**PCN-236063**

**Product Change Notice**

**Part Affected:**  
HSM8-C350

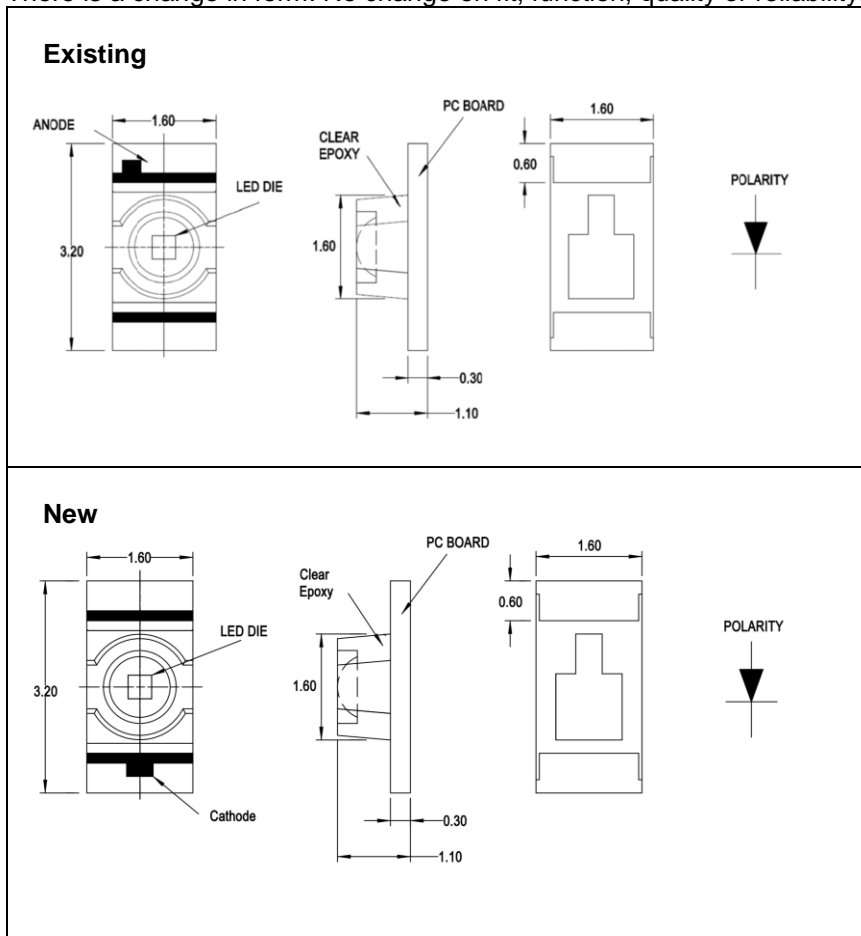
**Change Type:**  
Polarity marking

**Description and Extent of Change:**  
Change of polarity marking from anode to cathode.

**Reason for Change:**  
Standardization of polarity marking.

**Effect of Change on Fit, Form, Function, Quality, or Reliability:**  
There is a change in form. No change on fit, function, quality or reliability.

**Effective Date of Change:**  
Effective 16 Sep 2021, shipment will contain parts with new polarity marking
